Work Order ID 102958

Item Name: Crosstube Fwd High

DART AEROSPACE LTD	Work Order:	102958
Description: Crosstube High Fwd (205/212/412)	Part Number:	D212-664-101
Inspection Dwg: D212-664-141 Rev: D		Page 1 of 1

DRAWING NO. D212-664-141	TITLE XTUBE ASSY (205/212/412 HI FWD)	REV. D	DART AEROSPACE LTD ENGINEERING ORDER		D.E.O. NO. D212-664-141-D-1	SHEET NO. SHEET 1 OF 2	SCALE NTS
DRAWN	CHECKED	OP	MFG. APPR.	APPROVED	DE APPR.		
DATE 11.04.07	DATE 11.04.11		DATE 11.04.12	DATE 11/04/12	DATE 11.04.12

**D212-664-141/-141B
ASSEMBLY DETAIL**

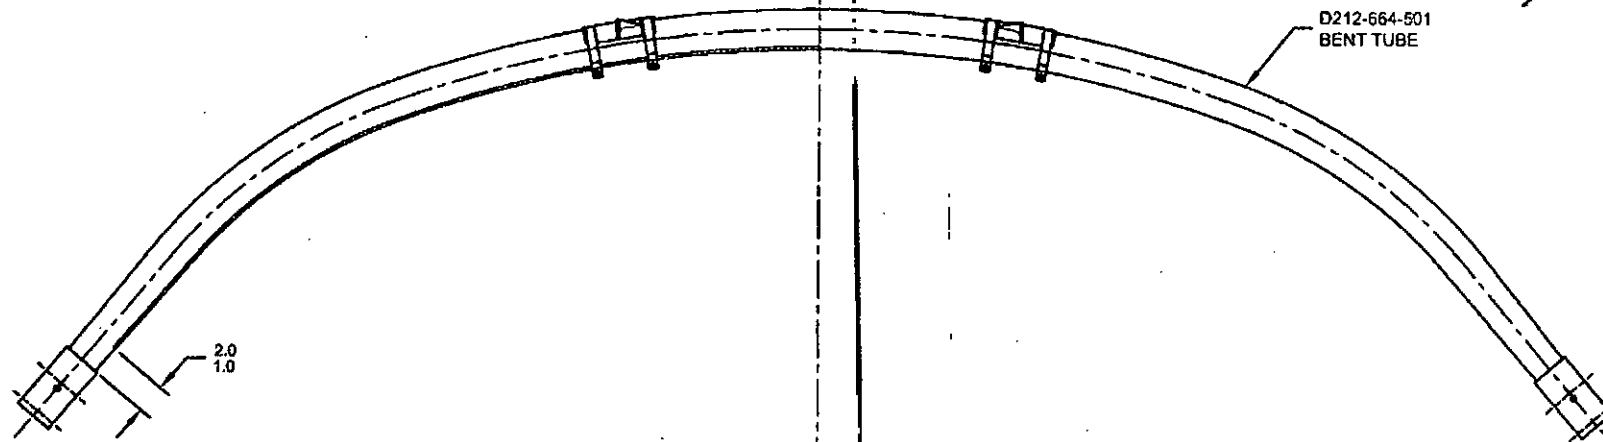
ADD AN INSPECTION WINDOW TO UNDERSIDE OF CROSSTUBE.

NOTES 2 OF SHEET 1 IS AMENDED AS FOLLOWS:

- 2) FINISH: CHEMICAL CONVERSION COAT PER DART QSI 005 4.1
PRIME INSIDE AND OUTSIDE PER DART QSI 005 4.2
MASK UNDERSIDE OF CROSSTUBE AS SHOWN (HATCHED AREA) AND
PAINT OUTSIDE PER DART QSI 005 4.2
REMOVE MASKING AND APPLY CLEAR COAT

MASK AREA PRIOR TO PAINTING.
REMOVE MASKING AFTER PAINT
AND APPLY CLEAR COAT
